NIRB File #: 11MN034

Re: Comment Request for Agnico Eagle's Meliadine Project 2024 Annual Report

GN AR # 01	
Department	Environment
Organization	Government of Nunavut
Subject/Topic	Raptor Surveys
Terms and Conditions	59, 71, 72 (Project Certificate No. 006, Amendment No. 2)
References	<ul style="list-style-type: none"> • Agnico Eagle Mines Limited – Meliadine Division. Appendix 26: 2024 Terrestrial Environment Management and Monitoring Plan Annual Report (March 2025) • Agnico Eagle Mines Limited – Meliadine Division. Terrestrial Environment Management and Monitoring Plan. Version 4 (April 2022) • Agnico Eagle Mines Limited – Meliadine Division. Opportunity to Address Comments Received for Agnico Eagle Mines Limited's Meliadine Gold Mine Project 2023 Annual Report (July 2024) • Government of Nunavut. Government of Nunavut Comments on Agnico Eagle Mine's Meliadine Project 2023 Annual Report. (June 2024).
IDENTIFICATION OF ISSUE	
<p>The Government of Nunavut (GN) notes that Agnico Eagle Mines Limited's (AEM or the Proponent's) 2024 Terrestrial Environmental Management and Monitoring Plan Annual Report (2024 TEMMP Annual Report) does not provide detailed information on raptor nest pr

Figure 1. Source: AEM, 2024a

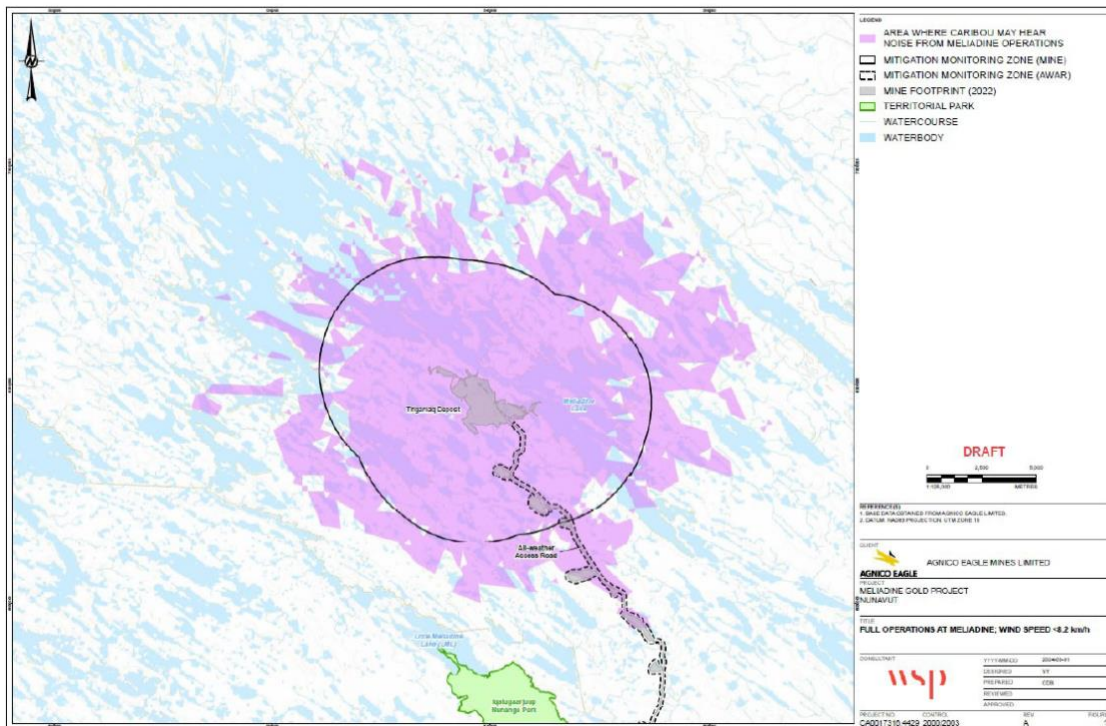
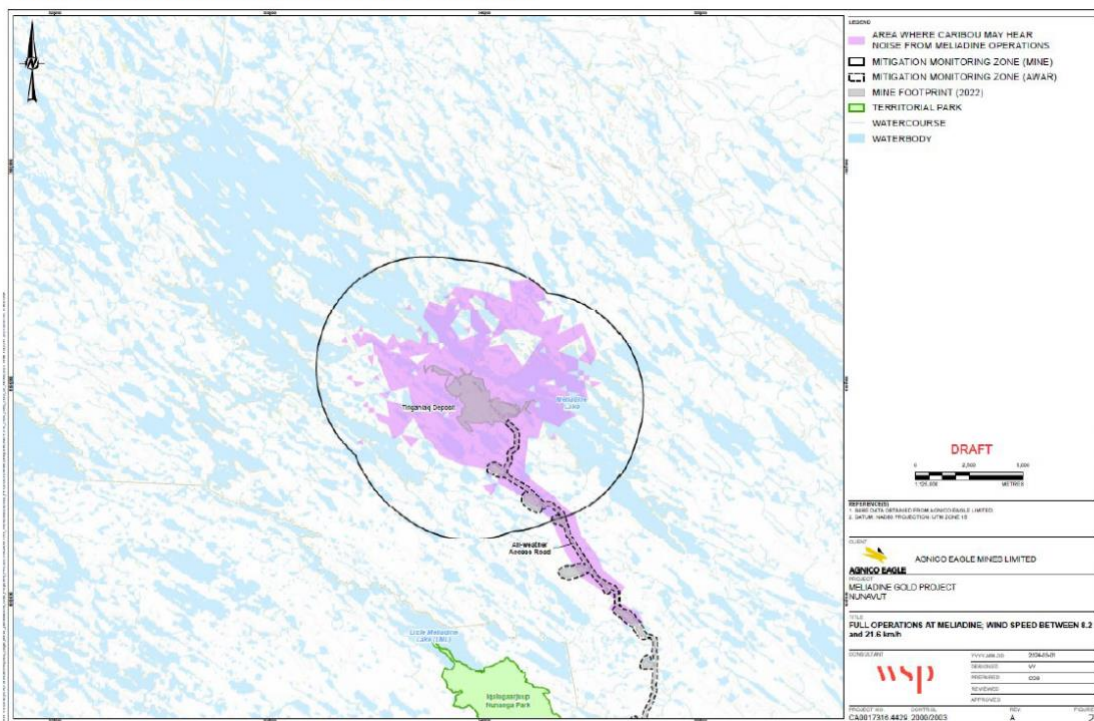
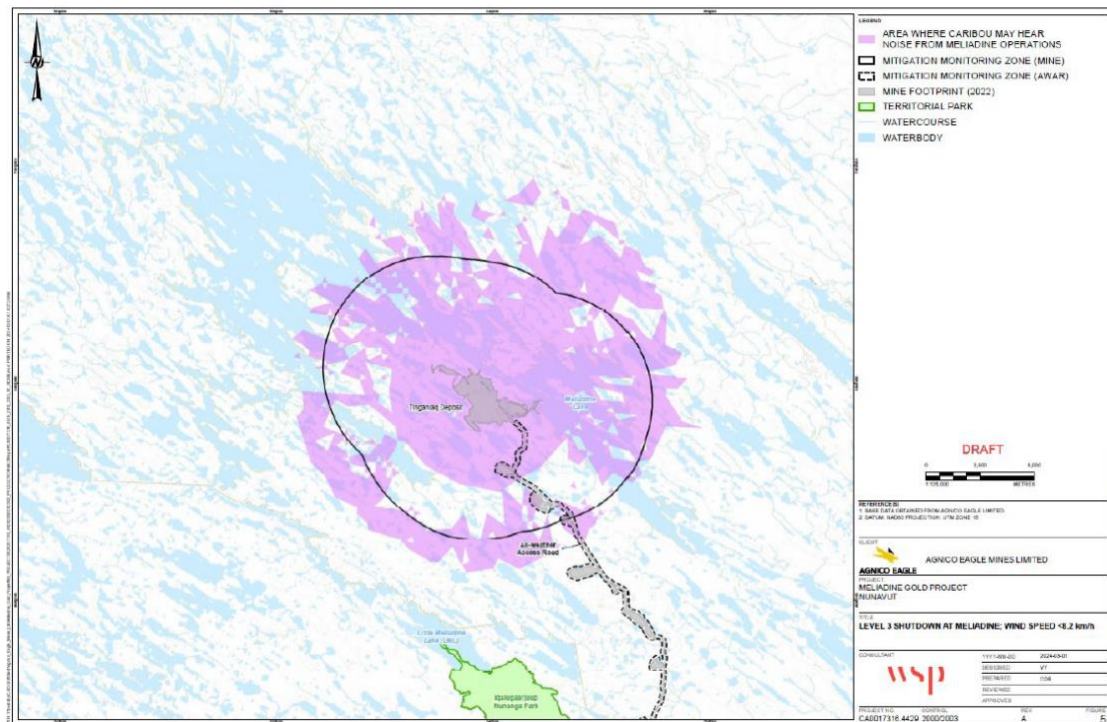
Selection of windspeed bands.

The noise analysis, as detailed in the 2024 TEMMP Annual Report, examined how wind-related noise may mask Project-related noise, reducing the distance at which caribou can detect it. The model used four windspeed bands (Figure 6; AEM, 2025a, p.38), with the lowest band (<8.2 km/h) based on the threshold for insect harassment (AEM, 2025, p. 37). However, the 2024 TEMMP Annual Report does not explain the rationale for the remaining bands, which vary in width and are not evenly distributed (Figure 6; AEM, 2025a, p.38). The widest band (8.2–21.6 km/h) accounts for approximately 62% of wind conditions from May to August, yet the analysis does not explore how results may vary with different band groupings (Figure 7; AEM, 2025a, p.39).

The GN believes that conducting the analysis with alternate windspeed bands could help assess sensitivity and improve relevance for caribou protection.

Additionally, the GN notes that while the <8.2 km/h band is reasonable for considering insect harassment in summer, it is not applicable during key sensitive periods for caribou, such as calving and post-calving.

Comparison of noise results to triggers for caribou protection

The Project's 2025 TEMMP uses a four-tiered system that increases monitoring and reduces mine operations as caribou approach the site; however, operational reductions only occur when 50 or more caribou are within 5 km of the mine (AEM 2025b, p. 62). Figures presented to the TAG in March 2024 (reproduced below for convenience; AEM, 2024a) shows that caribou detection of full operational noise is possible from over 10 km away in low winds (Figure 1) and up to 5 km away in moderate winds (Figure 2). Even when operations are suspended, noise may remain audible up to 10 km during low wind periods (Figure 3). These findings may suggest the current 5 km threshold for reducing operations is insufficient to minimize disturbance, particularly for calving and post-calving caribou.

The noise analysis appears to be constrained to modeling noise generated by the mine and the All-Weather Access Road (AWAR) but does not seem to account for noise emissions from drilling sites and other Project-related activities occurring on the land around the mine. These have the potential to expand the audible footprint of the Project beyond that presented by the Proponent.

1. Provide supporting rationale for the selection of each windspeed band used in the noise analysis.
2. Conduct a sensitivity analysis using alternative windspeed band groupings to evaluate how these affect the estimated distance and duration that caribou may be able to hear Project noise.

1. Clarify how noise from drilling operations and helicopter flights on the land surrounding the mine was considered in the 'full operations' scenarios. If these sources were excluded, revise the analysis accordingly and include updated maps and figures.
2. Explain how the current 5 km threshold for suspending mine operations is protective of calving and post-calving caribou, in light of the findings presented in the Proponent's noise analysis.
